## **URGENT: Medical Device Recall Notification**

### **AFFECTED DEVICE: Alaris™ Pump module Model 8100**

June 12, 2017

**Figure 1 - Image of Centered-Sear Safety Clamp Fitment (Affected Product - Sequester)**

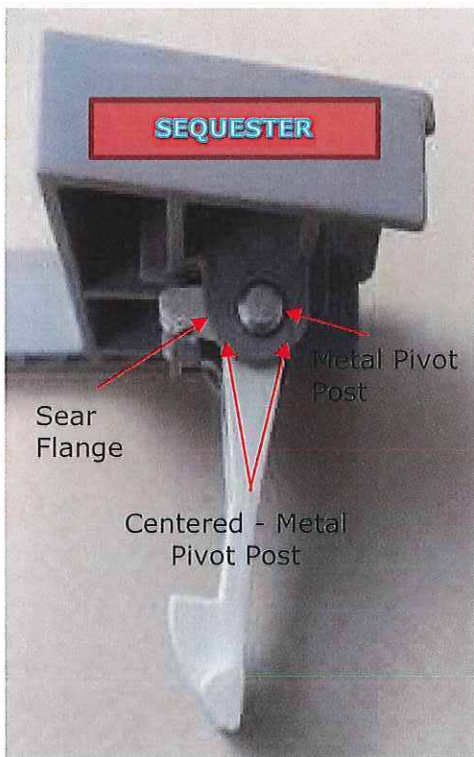
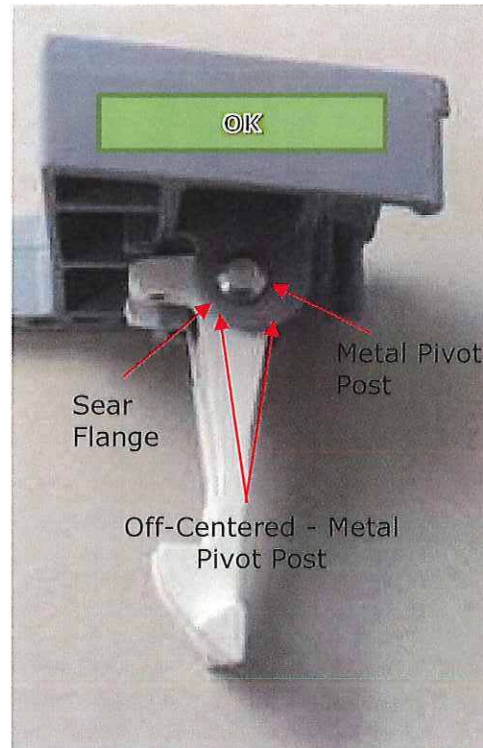
Using Figures 1 and 2 as a reference, visually examine the affected device to determine if the door latch has a centered-sear flange (the door latch mechanism may have been replaced after manufacture with an off-centered sear design). The centered-sear safety clamp fitment is identified by the centered position of the metal pivot post located on the inside of the door latch assembly sear flange.

- If your device has a centered-sear safety clamp fitment (Figure 1), clearly mark and sequester (e.g. Biomed department) the Alaris Pump module. Notify BD Support Center at 888-562-6018 or [SupportCenter@carefusion.com](mailto:SupportCenter@carefusion.com) to coordinate an onsite remediation or send the devices to the BD Service Depot.
- If your device has an off-centered safety clamp fitment (Figure 2) the device does not require remediation.

**Figure 2 - Image of Off-Centered-Sear Safety Clamp Fitment (Current Production - OK)**

Image of Centered-Sear Safety Clamp Fitment  
(Affected Product)

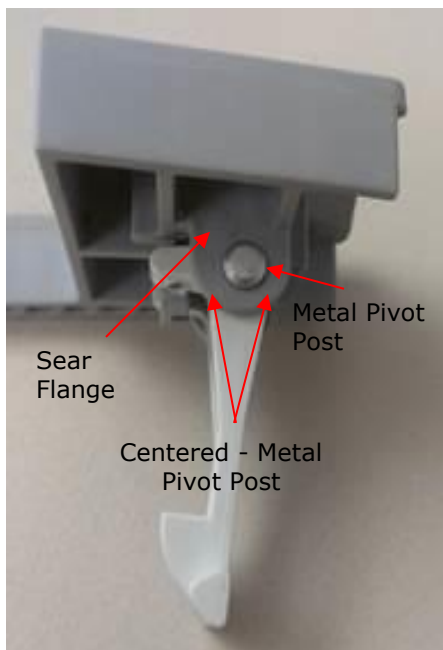
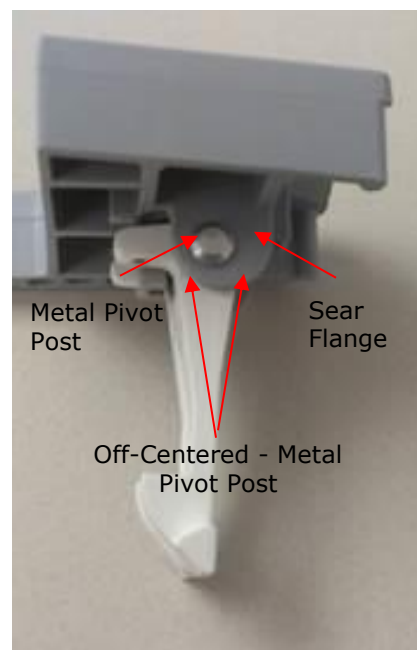
**16. How can the user visually identify the Alaris Pump module door latch for a centered-sear?**

The centered-sear safety clamp fitment is identified by the centered position of the metal pivot post located on the inside of the door latch assembly sear flange.

Image of Off-Centered-Sear Safety Clamp Fitment  
(Current Production)
